**GENERAL  
CORRESPONDENCE**

**GARY WILLIAMS ENERGY**  
**BISTI STATION**  
**SE 1/4 SEC 17 - T26N - R11W**  
**SAN JUAN COUNTY NEW MEXICO**

Subject  
 Bisti Crude Station (Gery Energy)

RE: REQUEST FOR CLOSURE, BISTI STATION, Southeast 1/4, Section 17, R-11W, approximately ten miles south of Bloomfield on Hwy. 44 and ten miles west on the Chaco Plant Road in San Juan County New Mexico, operated by Gary Williams Energy, TECI Project # 95043.

SUBJECT / NOTE(S): Here is the Amended  
Diagram for the Bist. project. Sorry  
about the quality of the other

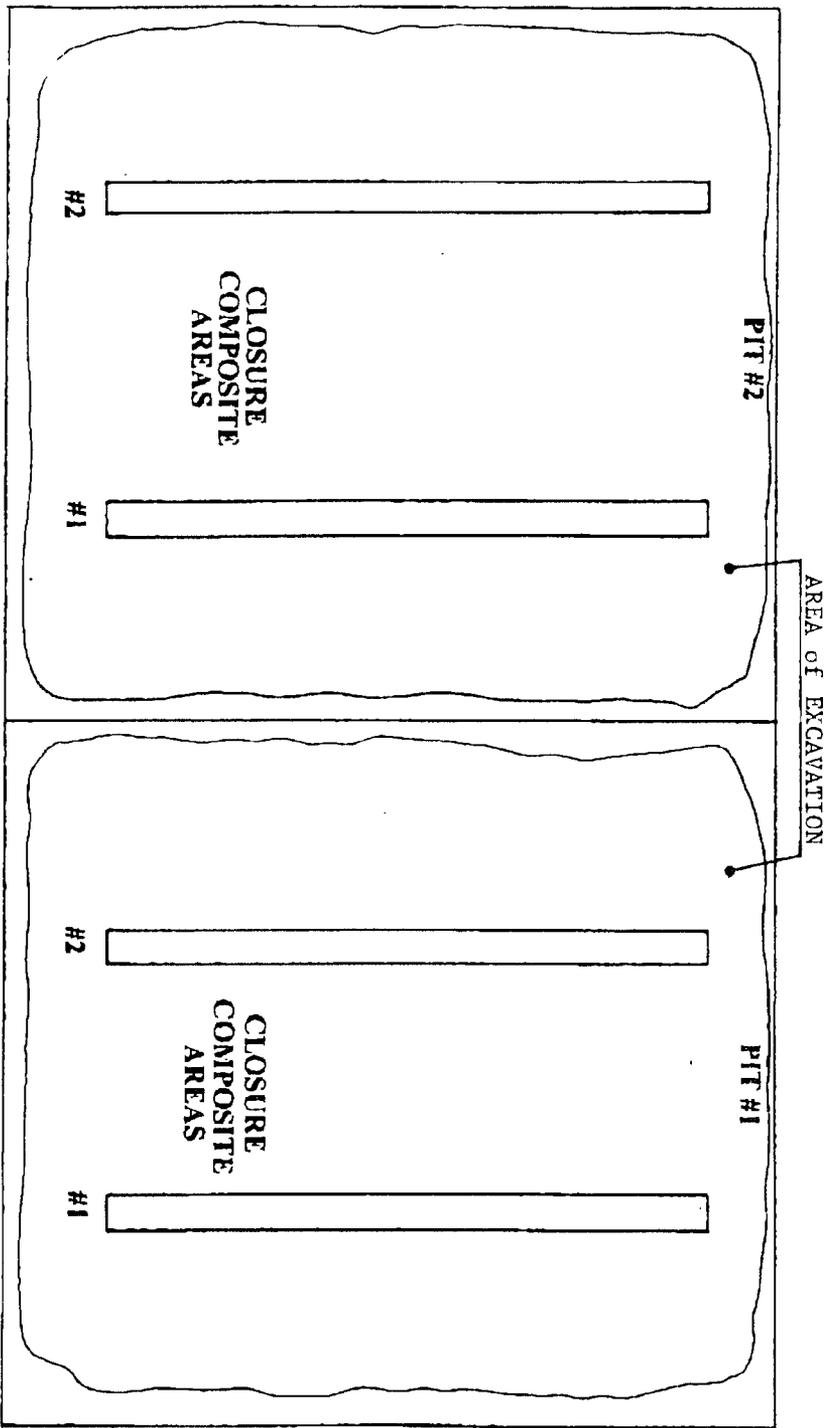
Discussion  
 OCD reviewed Bisti remediation report  
 Report is missing diagram showing locations of  
 excavated areas.  
 Also questioned location of TCLP soil analysis  
 He stated that diagram was oversight problem and that  
 TCLP soil analysis was from excavated soils from pits.

Conclusions or Agreements  
 He will send diagram ASAP
